Project	IEEE 802.16 Broadband Wireless Access Working Group < <u>http://ieee802.org/16</u> >
Title	Simplification of downlink STC in PUSC
Date Submitted	2004-11-01
Source(s)	Intel.
	Yuval Lomnitz Yuval.Lomnitz@intel.com
	Dov Andelman
Re:	IEEE P802.16REVd/D5-2004
Abstract	Corrections and clarifications of definitions for STC in OFDMA PHY.
Purpose	Adopt changes.
Notice	This document has been prepared to assist IEEE 802.16. It is offered as a basis for discussion and is not binding on the contributing individual(s) or organization(s). The material in this document is subject to change in form and content after further study. The contributor(s) reserve(s) the right to add, amend or withdraw material contained herein.
Release	The contributor grants a free, irrevocable license to the IEEE to incorporate material contained in this contribution, and any modifications thereof, in the creation of an IEEE Standards publication; to copyright in the IEEE's name any IEEE Standards publication even though it may include portions of this contribution; and at the IEEE's sole discretion to permit others to reproduce in whole or in part the resulting IEEE Standards publication. The contributor also a

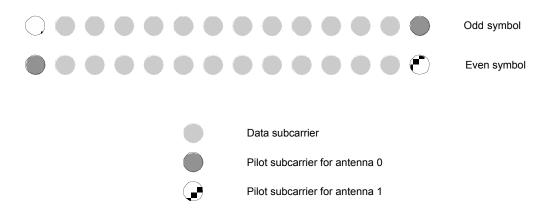
The definitions of STC coding for 2 antennas in downlink PUSC are overly complex, without any apparent reason. The definition by which data subcarriers are switched with pilots is difficult to understand and creates unnecessary complexity (a two layer permutation created by combination of PUSC permutation and subcarrier switching in STC). In addition, in the current definition STC is done over slots, which inserts an unnecessary delay and sensitivity to phase noise, puts an unnecessary constraint of the length of the STC zone (STC zone is required to be a multiple of 4 symbols instead of 2 - waste of up to 2 symbols) and differentiates between STC for FUSC and for PUSC.

Currently for FUSC, the pilot locations in the <u>permutation</u> definition are changed in order to accommodate STC, and STC encoding/combining is done on two adjacent symbols.

However in PUSC, the pilot locations in the permutation definition stay the same, but are then switched as part of the STC definition, and STC is done over two symbols. The switching was done in order to accommodate the fact that in the definition of STC the number of data subcarriers per cluster in odd and even symbols is not the same (the PUSC permutation is defined only for 12 data subcarriers per cluster per symbol). But a simpler definition is to use a constant number of data carriers per symbol and avoid the switching.

We propose to simplify the definitions by defining different pilot locations for PUSC, that will not necessitate subcarrier switching, and will make STC combining similar for PUSC and FUSC.

Figure 245 replaces Figure 234 in the definition of PUSC permutation when STC is enabled.

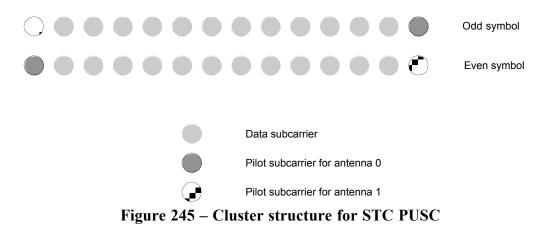
We propose that for STC in PUSC the pilot locations in the cluster will be changed as follows:

In PUSC the data allocation to cluster is changed (Figure 245) to accommodate two antennas transmission with the same estimation capabilities, each cluster shall be transmitted twice from each antenna.

STC encoding is performed on the two symbols of the PUSC slot (the even symbol with the odd symbol).
